HOWARD COUNTY HEALTH DEPARTMENT
BUREAU OF ENVIRONMENTAL HEALTH
3525-H ELLICOTT MILLS DRIVE/ELLICOTT CITY, MARYLAND 21043
TELEPHONE: 313-2640

Souder Builders, Inc. IS PERMITTED TO INSTALL ALTER
ADDRESS 9335 Old Scaggsville Road, Laurel, MD 20707 PHONE _____
SUBDIVISION Broadwater Estates ROAD 5674 Chamblis Drive LOT 10
PROPERTY OWNER ~~Ray Kinter~~ Lewis and Linda Walsh
ADDRESS _____

SOIL BERM NOTED AND REFINED
3/27/2000
Serial# B00120994
addition Bedroom Bath and 3 car garage

REPAIR - PURPOSE - In support of addition to existing house (B00120994)*
Please call for inspection when ground is open so sanitarian can recommend repair.

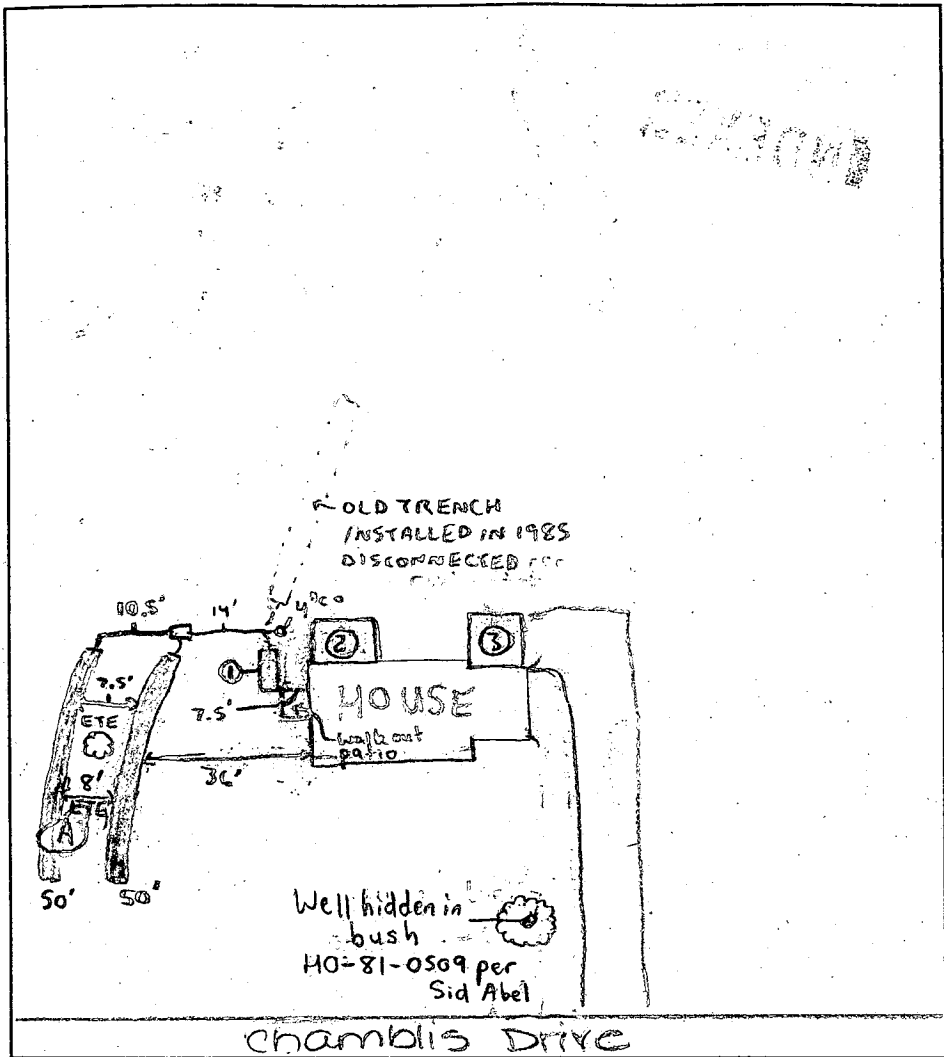
INSPECTION COMMENTS: 4/28/00 - OK TO INSTALL BOTH TRENCHES TOWARDS FRONT OF LOT, EXISTING SEPTIC TANK IS 7.5' TO HOUSE & ADDITION ① NOT BUILT 10' AWAY FROM EX. SEPTIC TANK. TRENCH (INSTALLED IN 1985) DISCONNECTED, OK TO CONTINUE WORK, WELL HAS OLD 1 PIECE CAP WITH SAFETY ROPE WRAPPED AROUND CASING, TAG ON WELL BUT BARELY VISIBLE BECAUSE OF SURROUNDING BUSH (SRW) 4/28/00 - OK TO COVER ALL WORK ② AND ③ ARE LOCATIONS OF PROPOSED ADDITIONS (SRW)

SHOW MAJOR FEATURES OF BOX & LOCATE WELL WITH AN X
 SOURCES OF DRILLING WATER
 1. well
 2.
 3.
 WRITE THE BOX NUMBER FROM THE MAP HERE
 E **810 0**
 N **500 5**

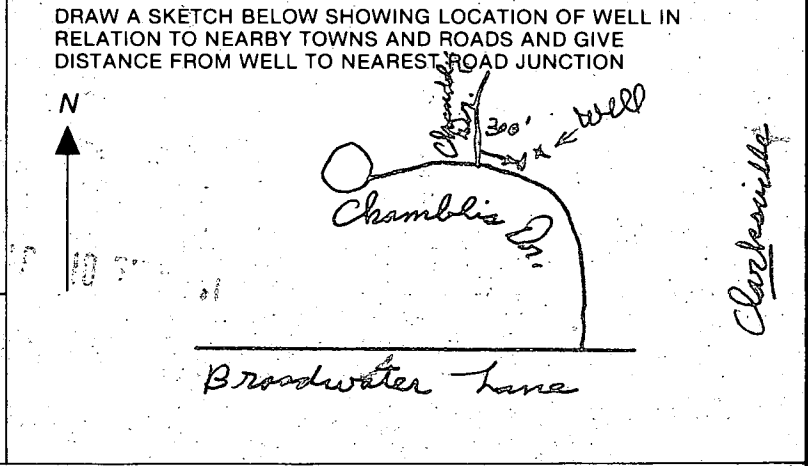
LOCATION OK
 65 FT CASING
 1 FT ABOVE GR.
 55' + OPEN
 14 BAGS CEMENT
 5/9/84 CW

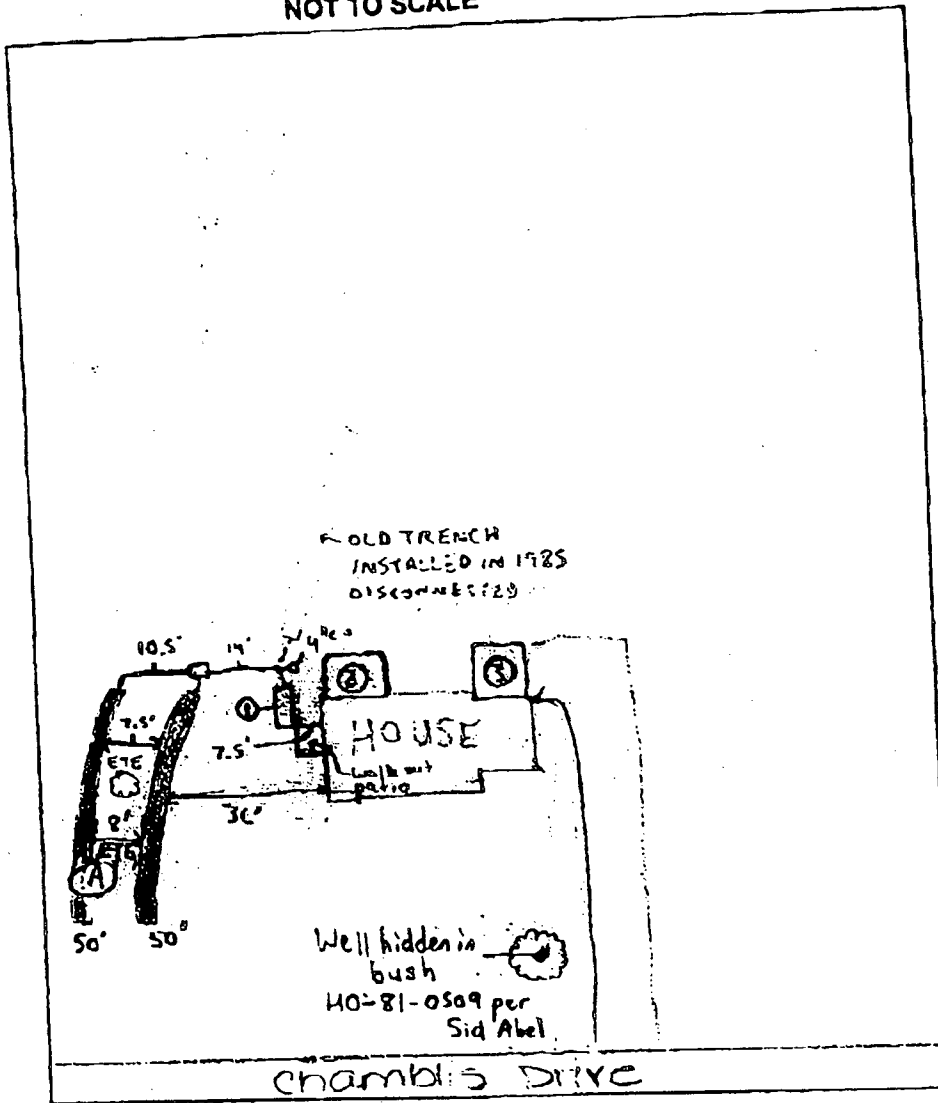
INSPECTION COMMENTS: 4/28/00 - OK TO INSTALL BOTH TRENCHES TOWARD
 EXISTING SEPTIC TANK IS 7.5' TO HOUSE & ADDITION ①, TRENCH INSTALLED IN 1985
 OK TO CONTINUE WORK, WELL HAS OLD 1 PIECE CAP WITH SAFETY ROPE L
 CASING, TAG ON WELL BUT BARELY VISIBLE BECAUSE OF SURROUNDING B
 OK TO COVER ALL WORK, ② AND ③ ARE LOCATIONS OF PROPOSED ADDITION
